**HOWELL TOWNSHIP PLANNING COMMISSION
REGULAR MEETING - RESCHEDULED**

- B. Wrangler’s Saloon Restaurant, PC2024-10, 4020 W. Grand River Ave. Howell, MI 48855, Parcel #s 4706-20-400-004, 4706-20-201-017, 4706-20-201-018. Final Site Plan Review.

**HOWELL TOWNSHIP PLANNING COMMISSION
REGULAR MEETING MINUTES**

C-6.1

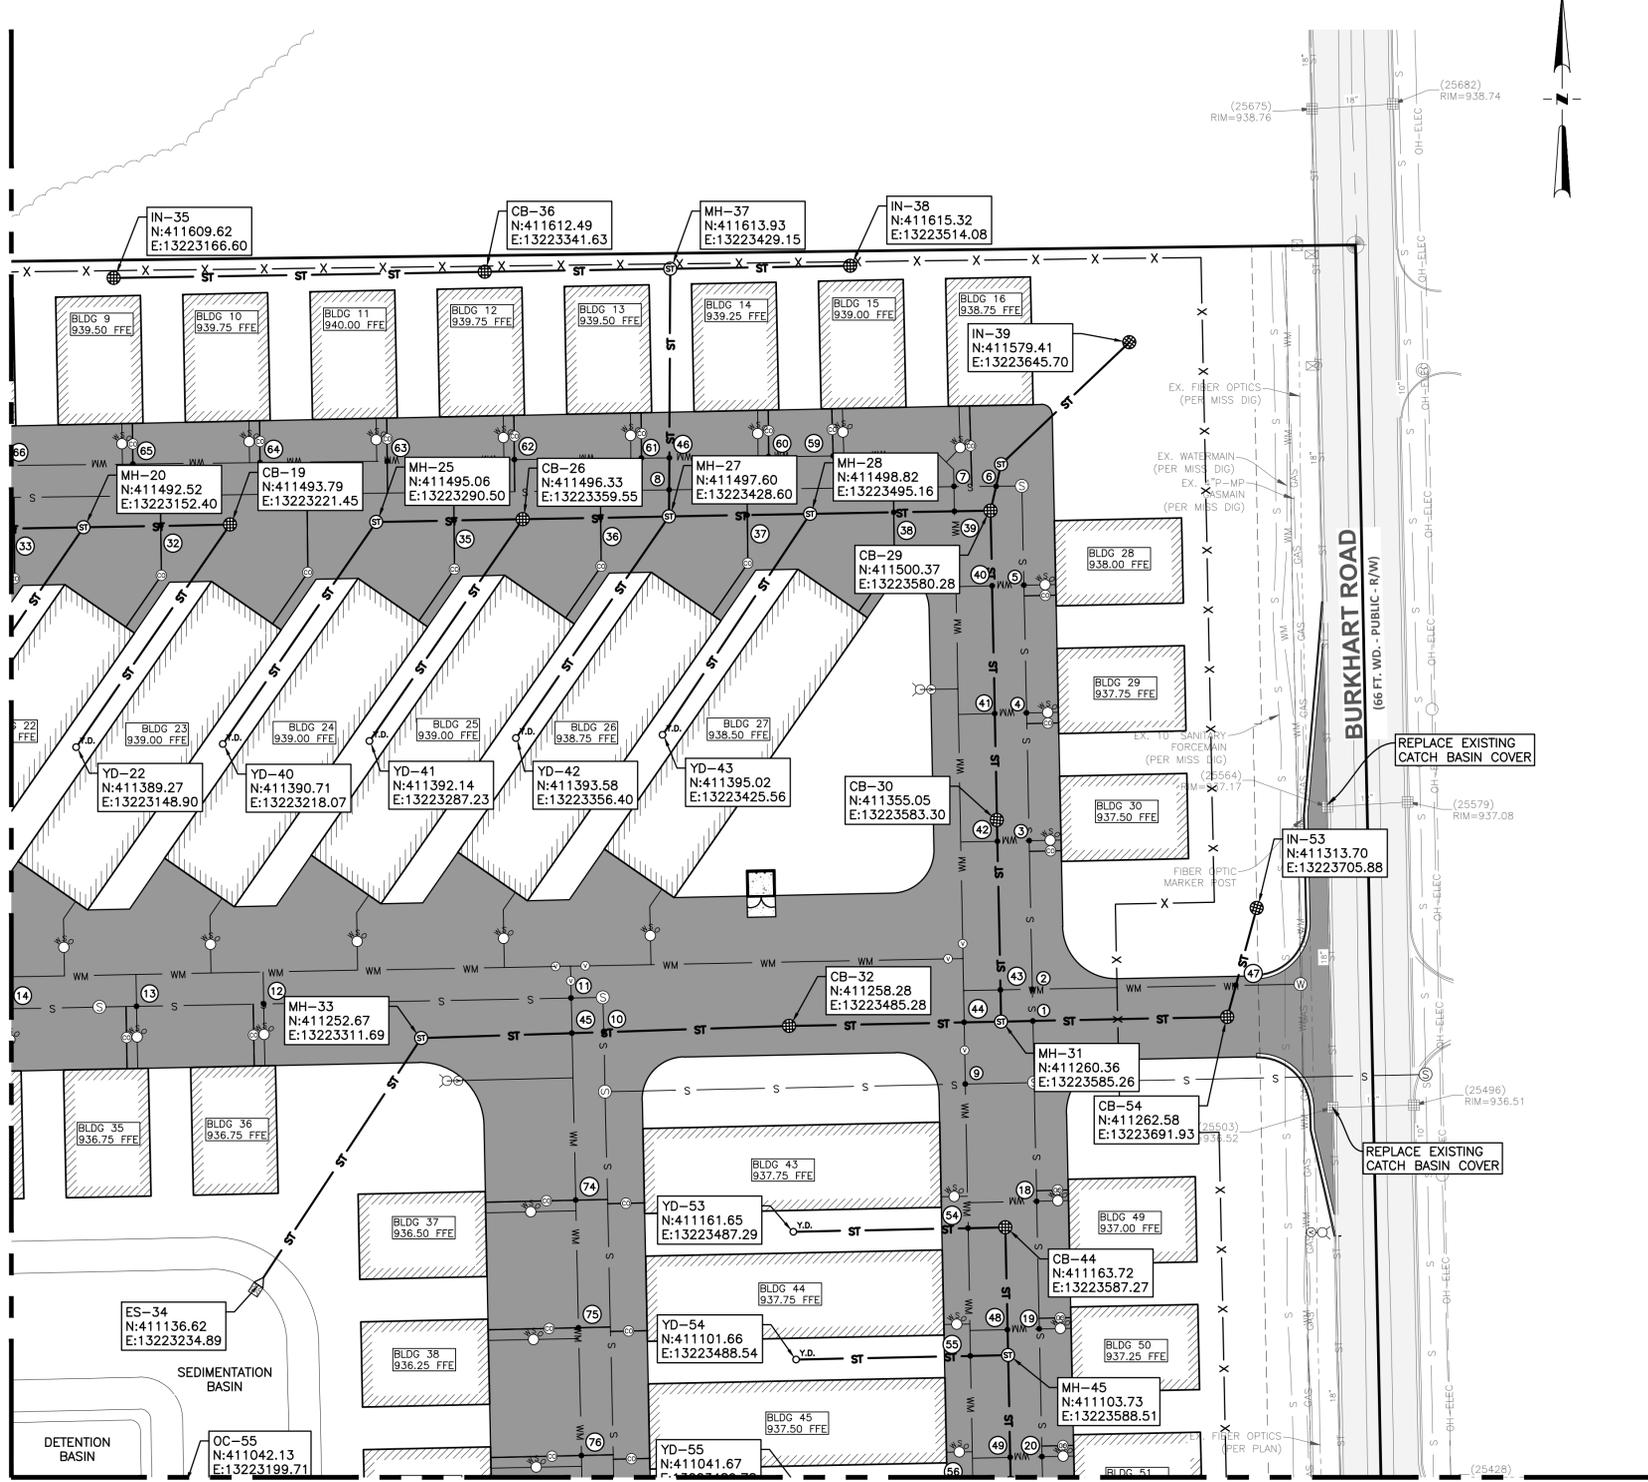
The plans should include pipe lengths, diameters, slopes, rim elevations, and inverts on the plan sheets C-6.1, C-6.2, and C-6.3.

The plans should include pipe lengths, diameters, as well as rim elevations, and inverts for each structure on the plan sheets C-6.1, C-6.2, and C-6.3.

8. Include pipe lengths, diameters, slopes, rim elevations, and inverts on the plan and profile sheets. **Included on profile Sheets C-6.4 through C-6.7**

DESIGNED BY: PC
 DRAWN BY: PC
 CHECKED BY:
 SCALE: 1" = 30'
 JOB NO: 21-550
 DATE: 6-25-24
 SHEET NO. **C3A**

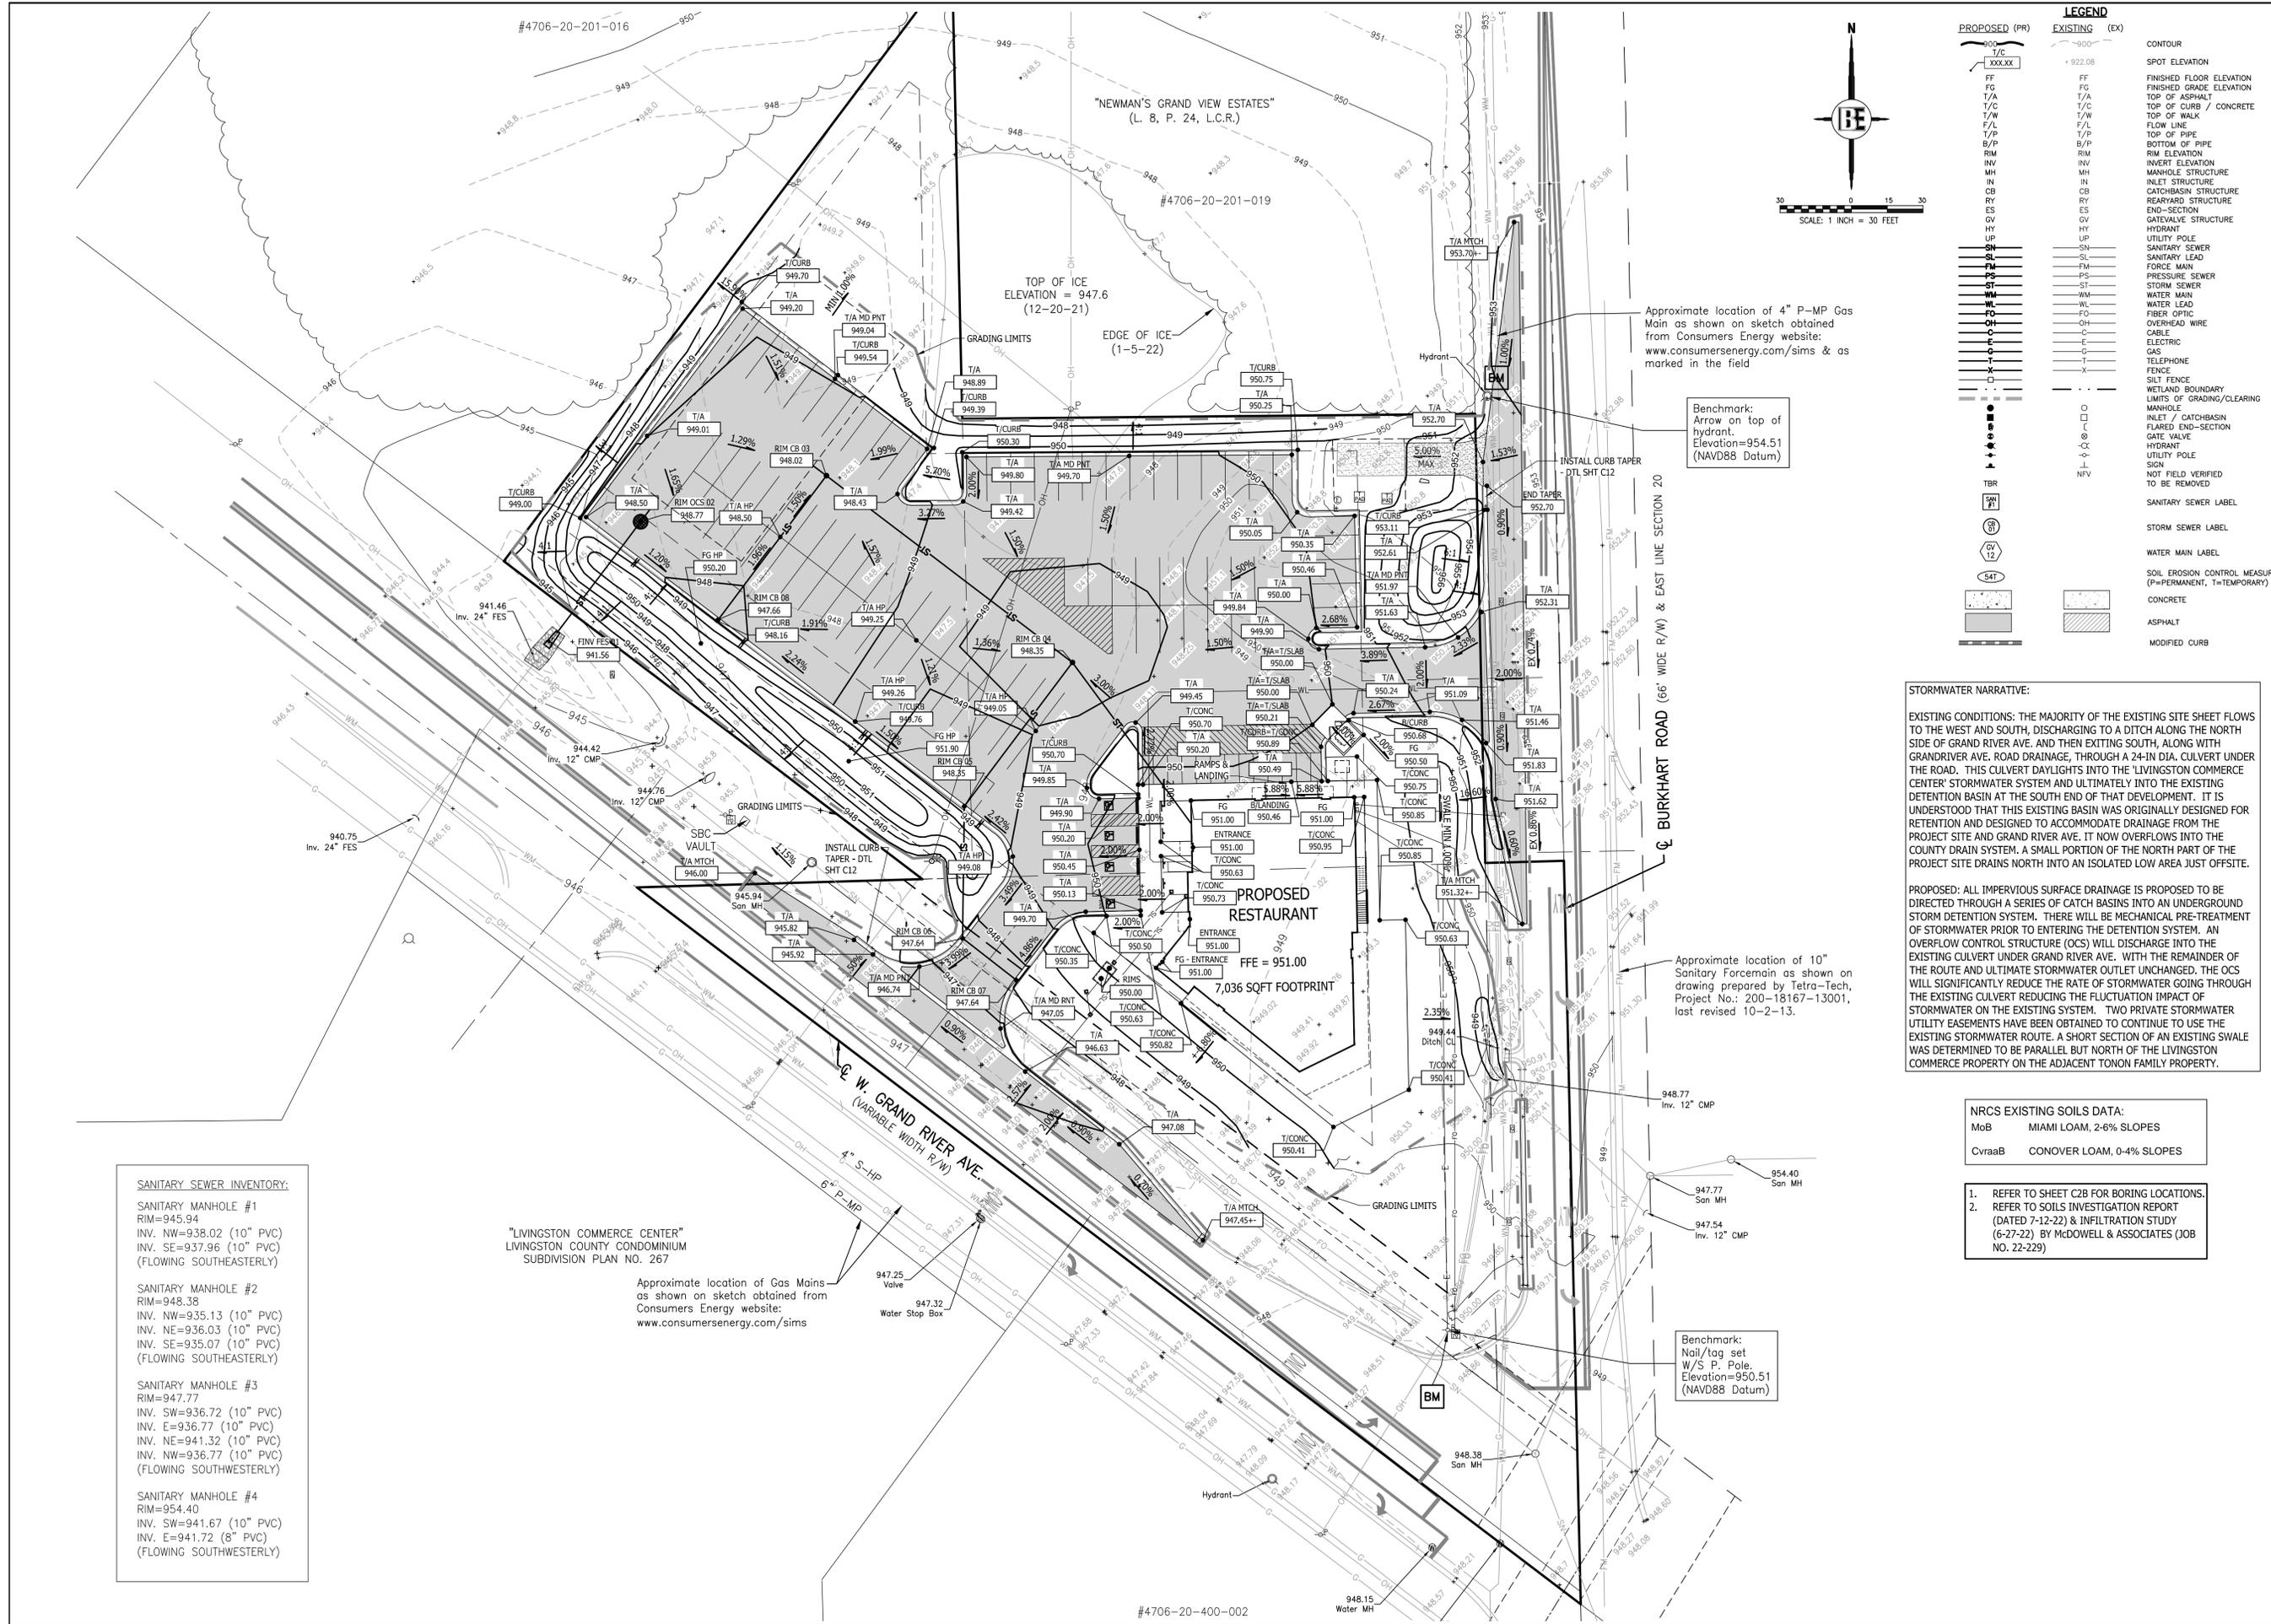
The building height has been included on Sheet C3A in the table Site Statistical Data. The rear yard setback of fifty (50) feet is now shown on Sheet C3A.

1. Building Height Clarification: The building height of 39'-6-1/2" has been added to the Site Statistical Data summary on the Site Plan, Sheet C3A. Also shown on the architectural plans.
2. Rear Setback: A 50-ft rear yard setback has been added to the drawings as per Planner email dated 4-23-24 and accepted by the Plan Commission on 4-23-24.
3. No Parking in Setback: There is no parking in the setbacks.
4. Proposed Signage: Acknowledged. Signage will be separately submitted for permitting.

C1

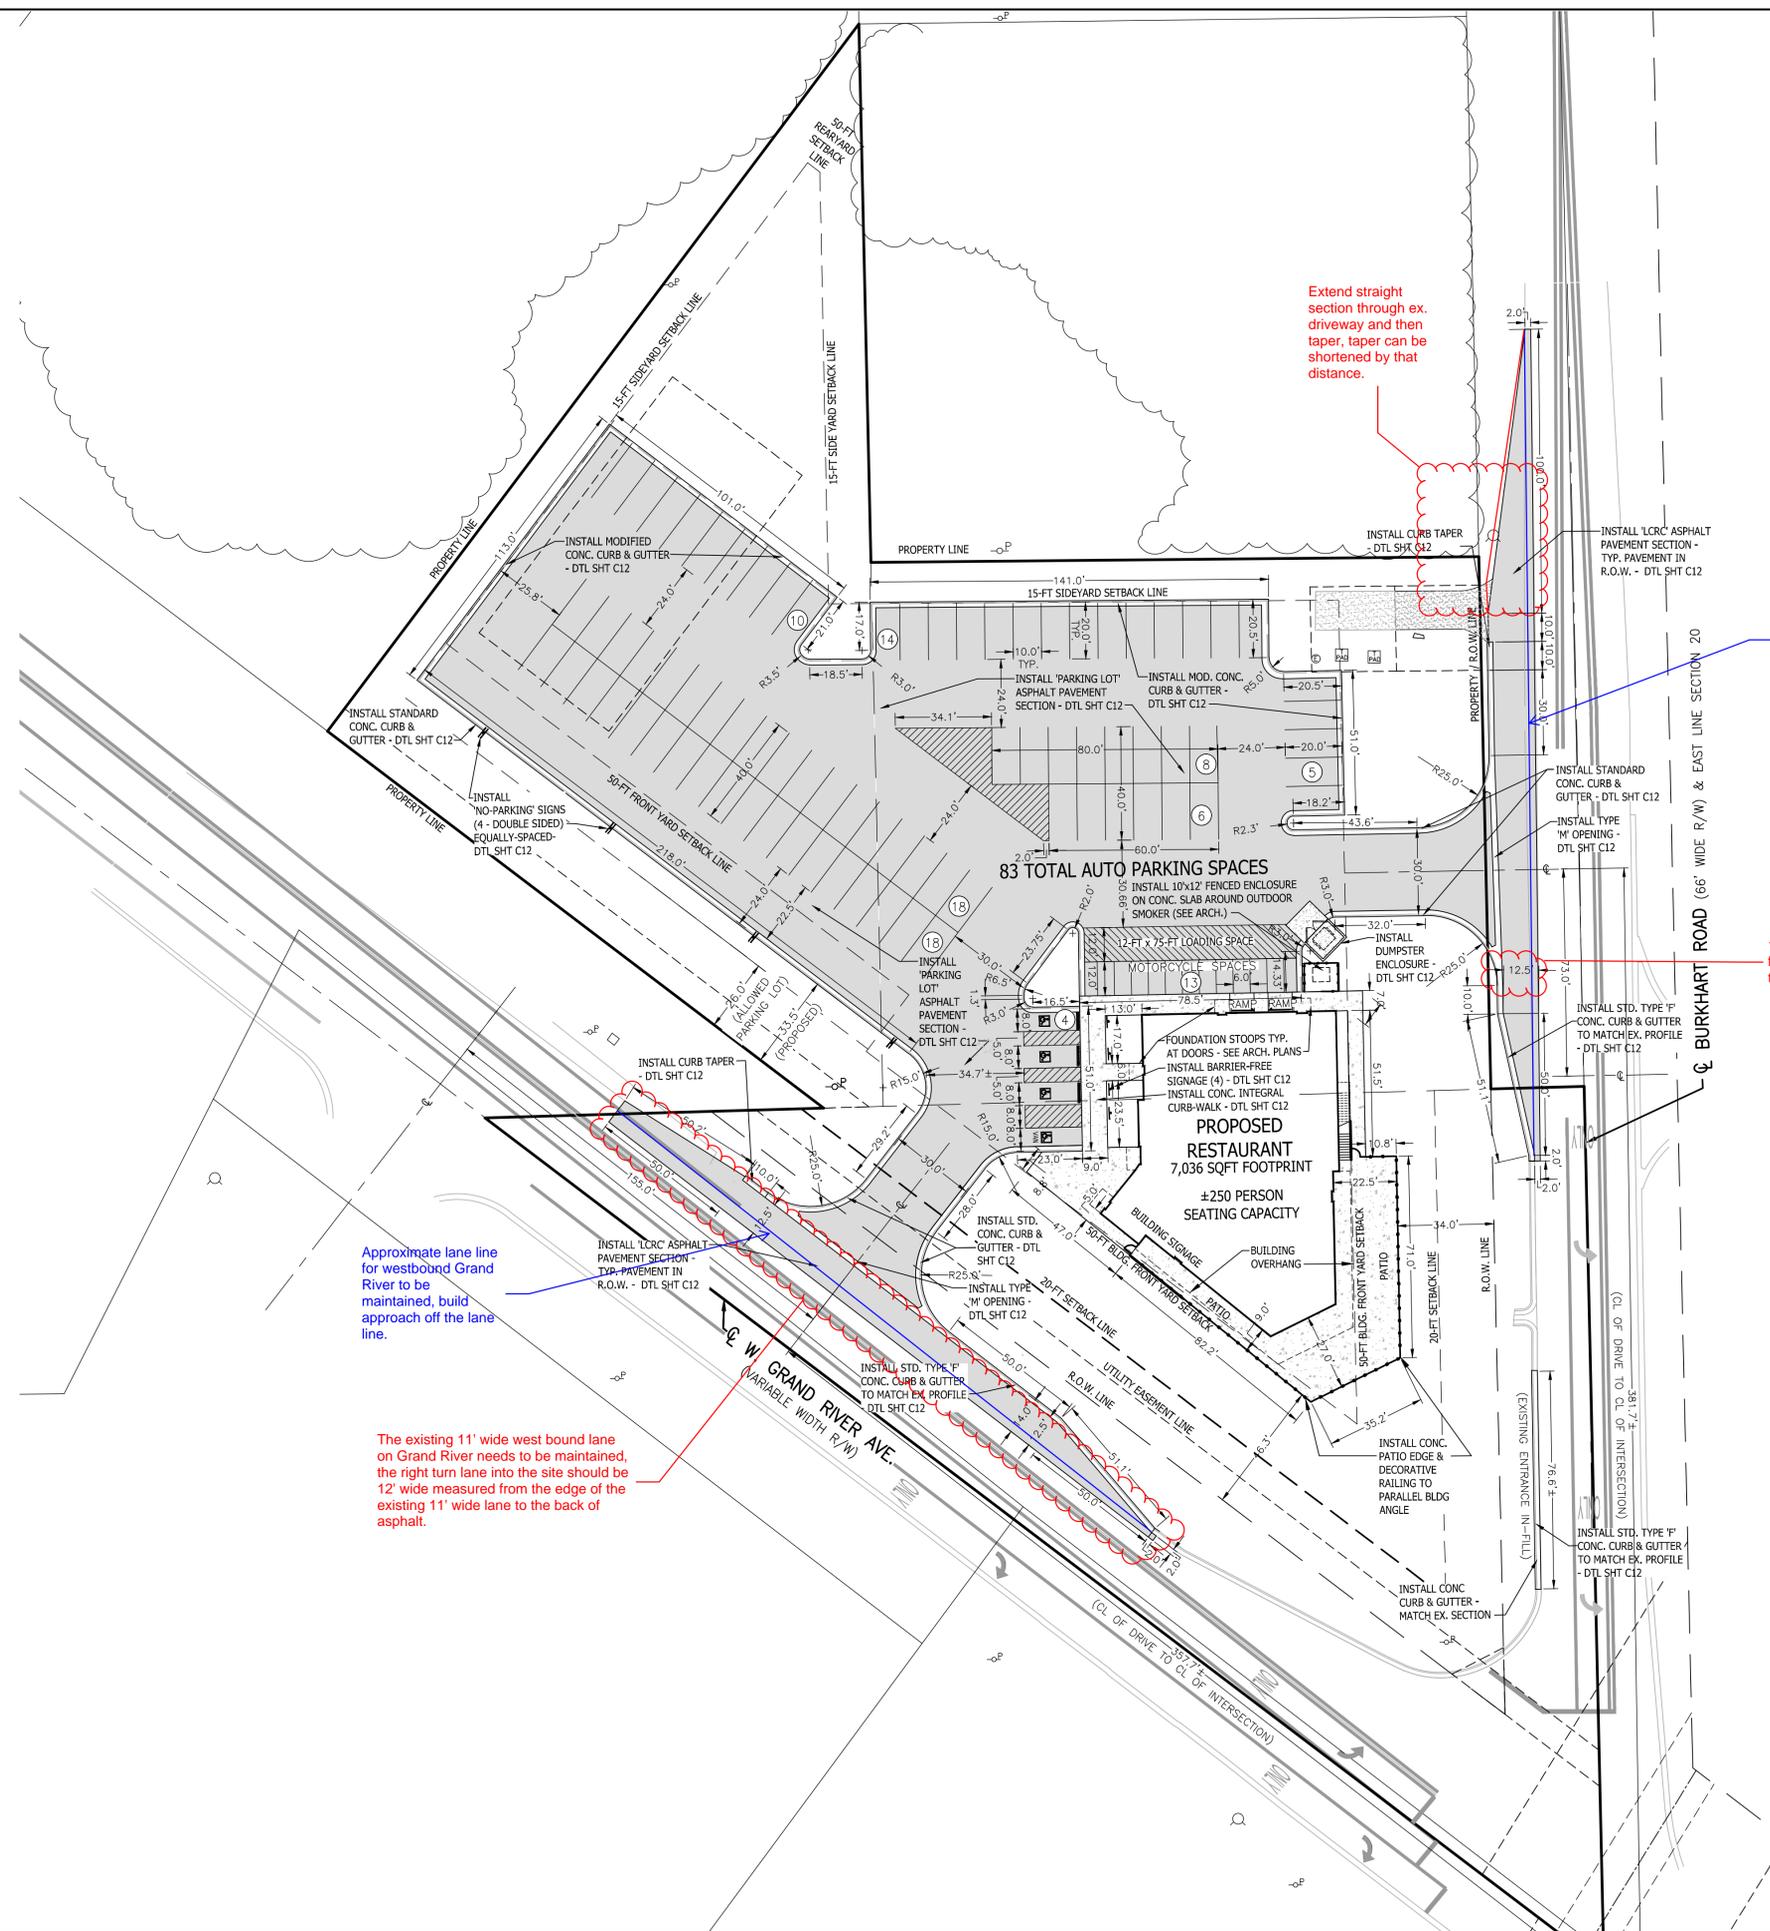
Extend straight section through ex. driveway and then taper, taper can be shortened by that distance.
